Tarheel Lodging
Written Narrative and
Proposed Plan and COA Modifications (Buildings 3/4 and 5)

August 23, 2022
Updated August 30, 2022
Updated October 14, 2022
Updated November 08, 2022

Having recently completed a portion of the Phase-I TRU Hotel development, The developer is requesting a modification to the current Certificate of Appropriateness (COA) to incorporate minor changes to the multi-family building including updated floor plans. The following is a listing of proposed modifications to the plans including some previously approved Design Alternates.

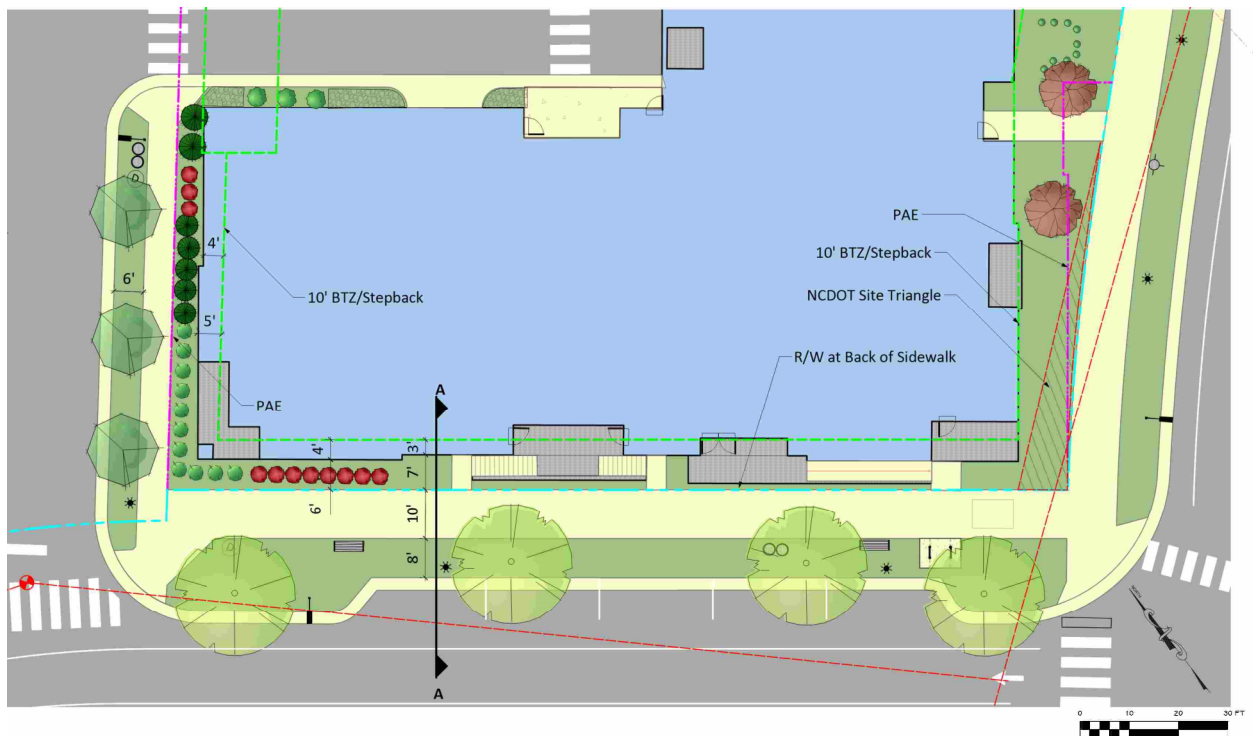
5. Transformer located within 4.5 ft of sidewalk on Street-A at garage entrance with architectural screening proposed.

Justification: Duke Energy's requirements for separation from doorways and windows combine to leave no other alternative for alternate locations.

Design Alternate 21 - As Submitted with 4'-5' Encroachments into Novus BTZ and Street-B

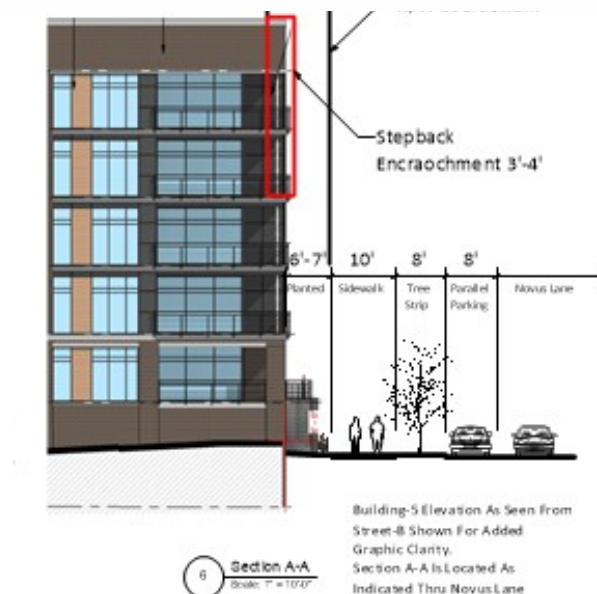
2. Design Alternate-21 Section 3.D. Building Step Back

- a. Building-5 Request modification for exemption from Building Step Back requirements along Novus Lane and Street-B above the 3rd floor. This is being requested to maintain the continuity of the streetscape and alignment of buildings along Novus.
